**STAFF RECOMMENDATION**  
**1207 Dallas Avenue**  
**December 19, 2018**

**Application:** Partial Demolition; New Construction—Addition and Outbuilding  
**District:** Belmont-Hillsboro Neighborhood Conservation Zoning Overlay  
**Council District:** 18  
**Map and Parcel Number:** 11801006200  
**Applicant:** Jason Peveler, Peveler Construction  
**Project Lead:** Sean Alexander, sean.alexander@nashville.gov

<p><b>Description of Project:</b> The applicant proposes to enlarge an historic one-story house with a rear addition that will be wider than the historic house. A one and one-half story outbuilding is also proposed. The outbuilding is not depicted as being a DADU.</p> <p><b>Recommendation Summary:</b> Staff recommends approval of the proposed addition and outbuilding with the following conditions:</p> <ol style="list-style-type: none"><li>1. Staff shall approve all exterior materials; and</li><li>2. Staff shall approve the window and door selections.</li><li>3. HVAC units and mechanicals shall be located behind the midpoint of the building.</li></ol> <p>With these conditions, staff finds that the addition meets Section II.B of the <i>Belmont-Hillsboro Neighborhood Conservat

**BACK ELEVATION**

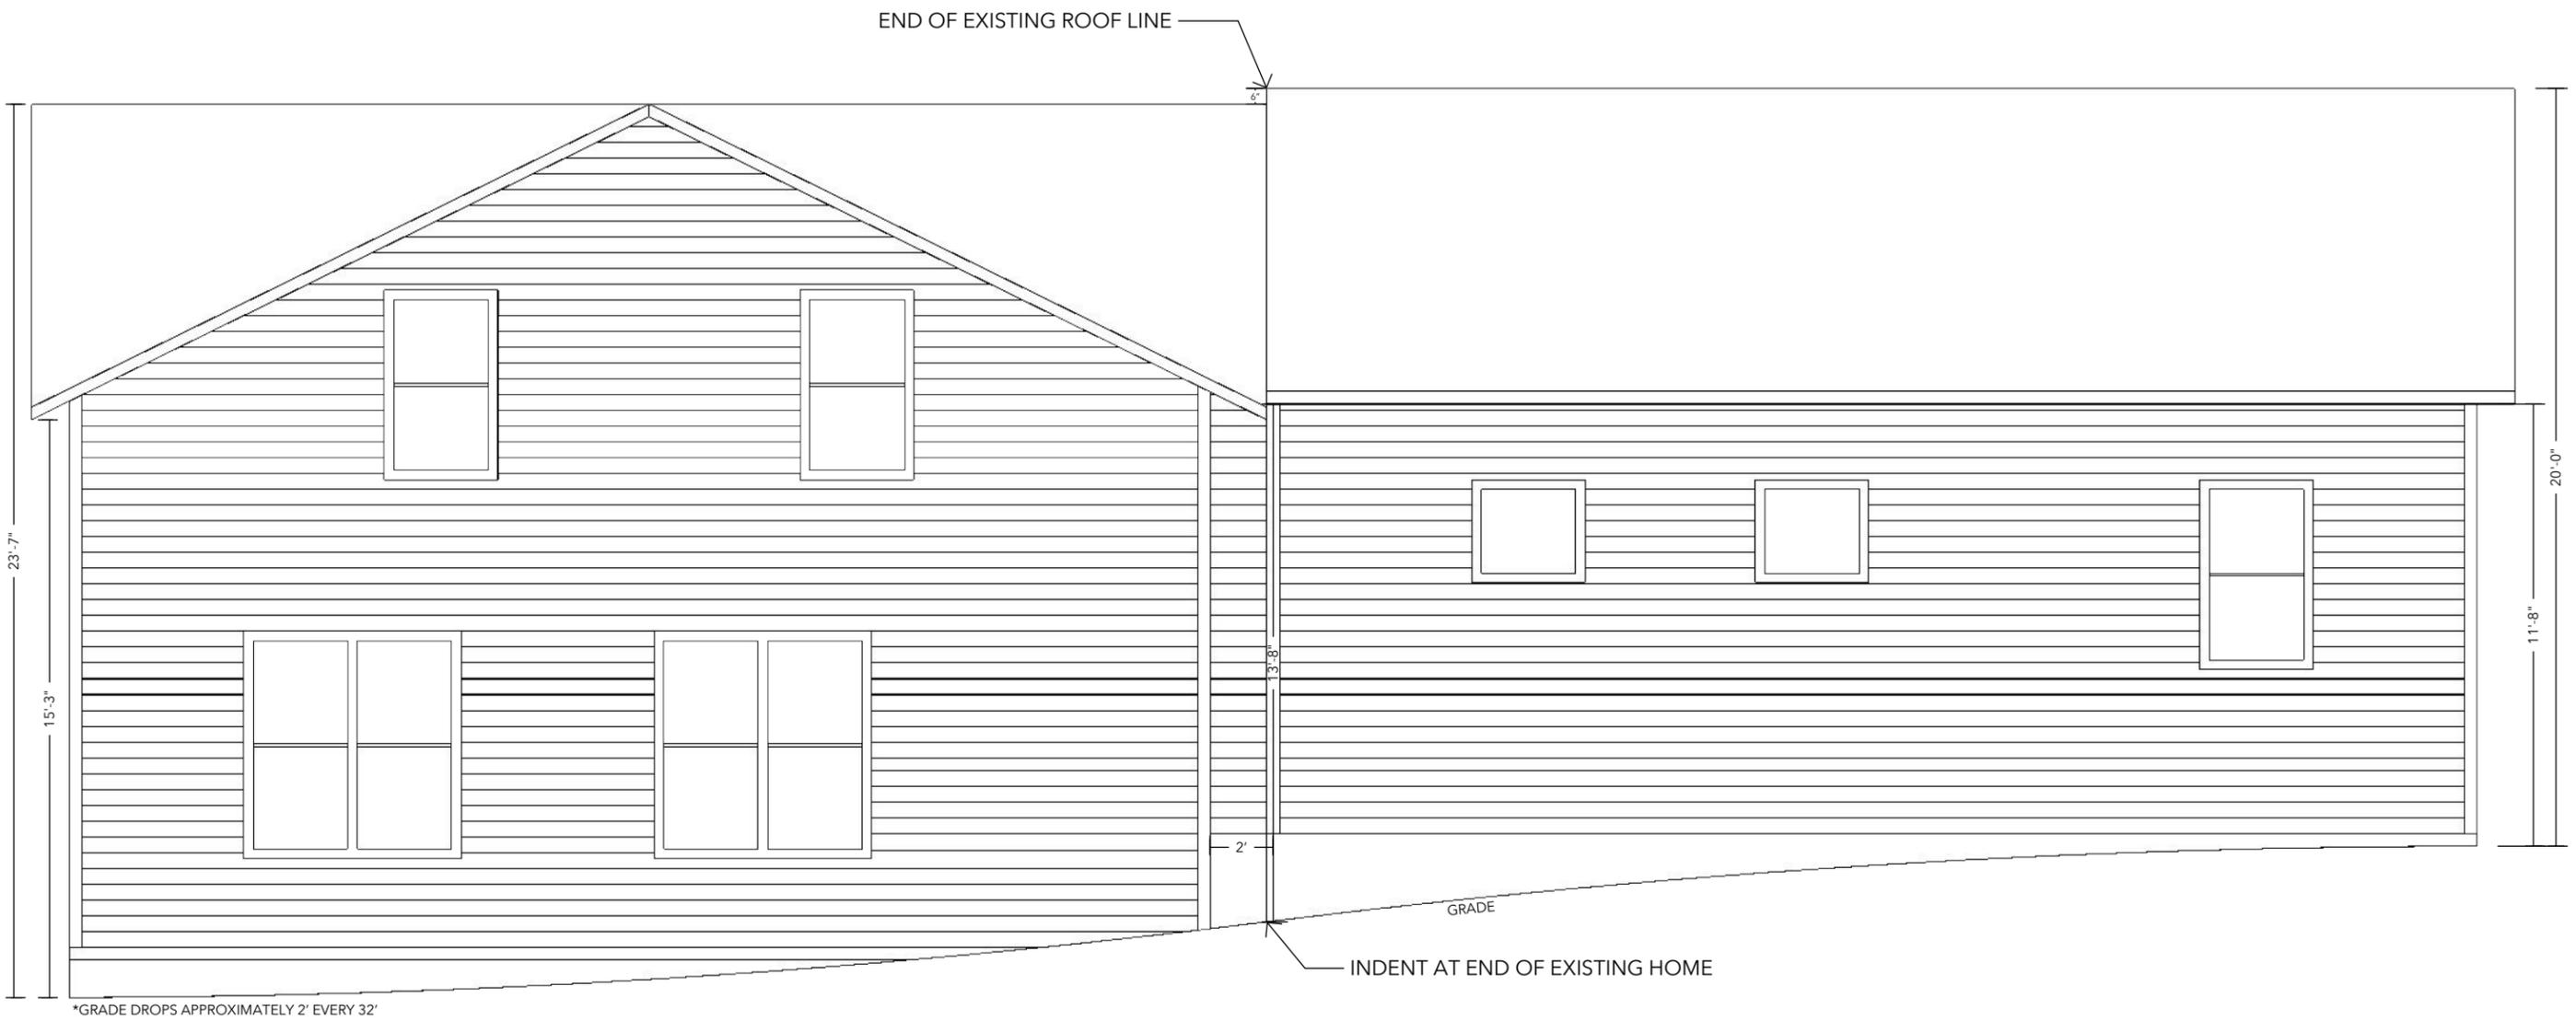
The addition's roof will sit six inches (6") below the ridge of the historic house, and the eaves of the addition and the house will align.

Roof form: The primary roof of the addition will be a cross-gable, with roof pitches between 5:12 and 6:12, lower than the pitch of the original 12:12 gabled roof. It is not uncommon for houses to have more than one roof pitch, particularly when the roofs are the same form. Staff finds that the roof forms of the addition are compatible with the historic house and the project would meet Section II.B.1.e of the design guidelines.

**WEST ELEVATION**

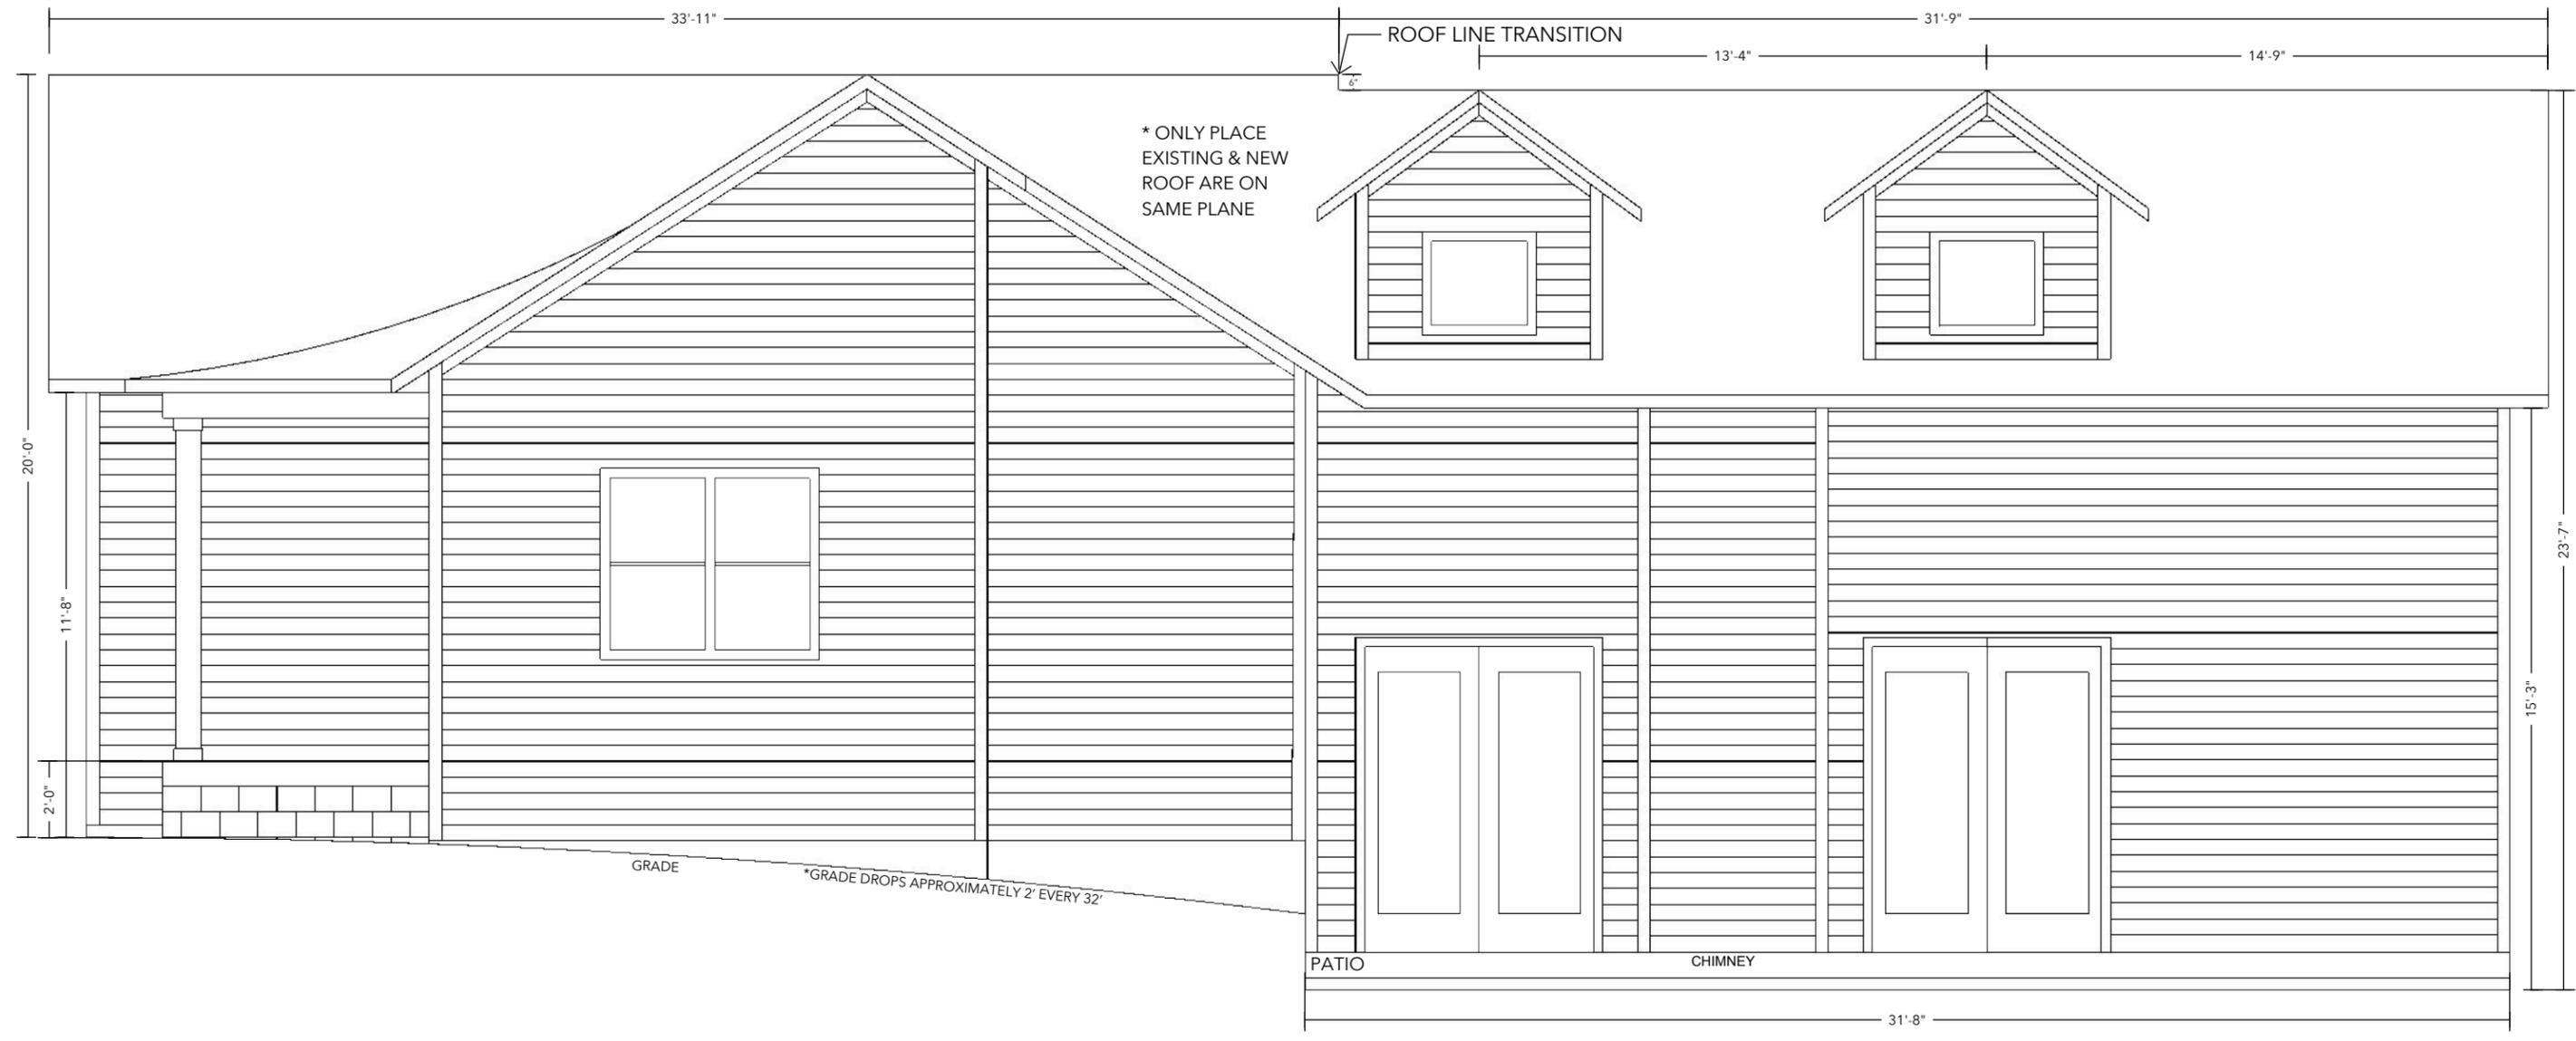
Proportion and Rhythm of Openings: Most of the windows on the proposed addition are generally twice as tall as they are wide, which is typical of the historic proportions of openings. The front portion of the addition that extends wider has small windows that are almost square. Due to the drop in grade this portion reads as one-story but is actually

two-stories so a more proportionate window is not possible without the new windows crossing the floor line. There are no large expanses of wall space without a window or door opening. Staff finds the project’s proportion and rhythm of openings to meet Section II.B.1.g of the design guidelines.

**GARAGE FRONT ELEVATION**

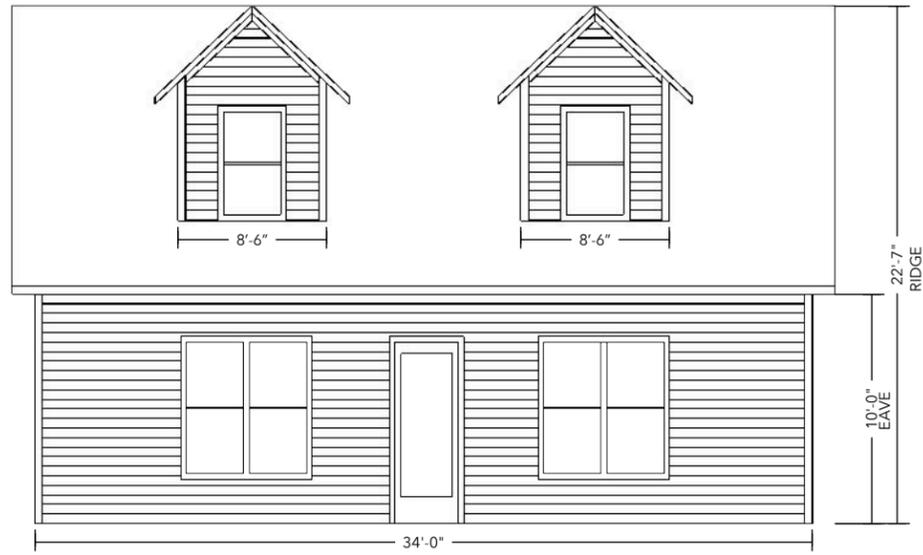
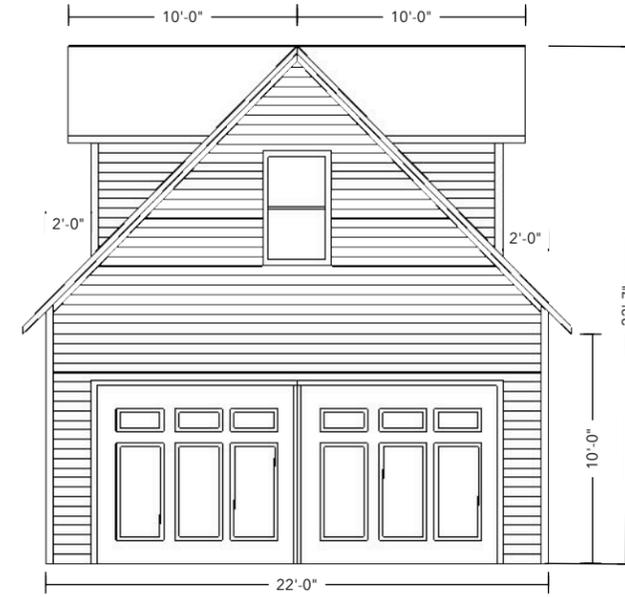
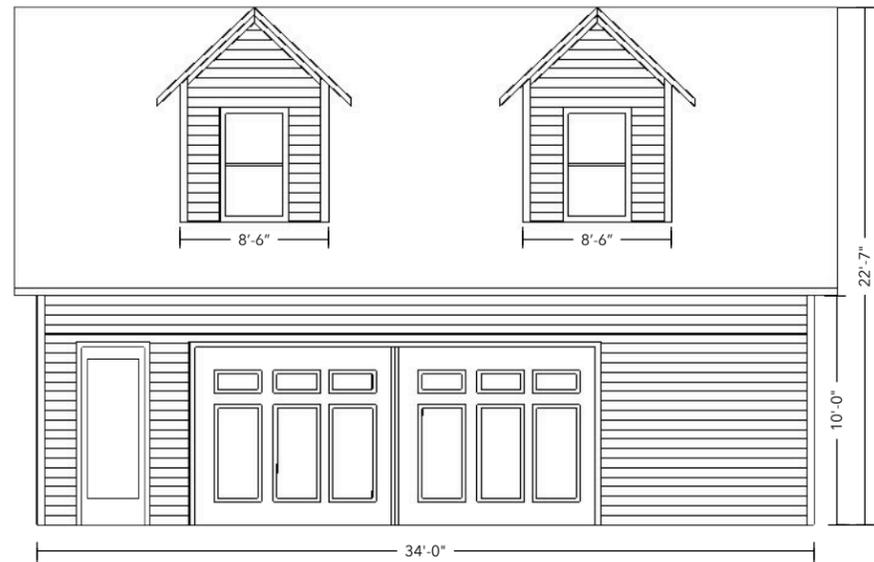
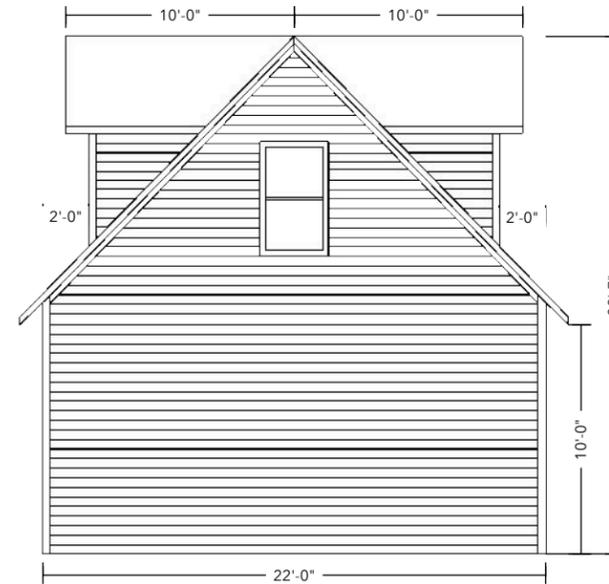
The footprint of the new DADU is seven hundred, forty-eight square feet (748 sq. ft.), which is less than the maximum for outbuildings for a lot of this size. The twenty-two foot, seven inch (22’-7) roof height will be than the roof of the historic house, however, because the grade drops toward the rear of the lot the height will be less than the average roof height. The eave height of the outbuilding will be ten feet (10’). Staff finds that the height and scale of the proposed outbuilding meets the design guidelines Section III.B.2.h.1 of the design guidelines for height and scale.

The proposed roof form has a side-gabled roof which is a common roof form for outbuildings, and is compatible with the roof of the historic house. The dormers meet the guidelines for width at fifty percent (50%) of the roof width and they sit back two feet

(2') from the wall below. Staff finds that the application will meet Section III.B.2.h.1 of the design guidelines for roof shape.

No materials are indicated on the submittal. For the materials to meet Section II.B.1.d, staff recommends final approval of all proposed materials prior to purchase and construction.

1. Staff shall approve all exterior materials; and
2. Staff shall approve the window and door selections.
3. HVAC units and mechanicals shall be located behind the midpoint of the building.
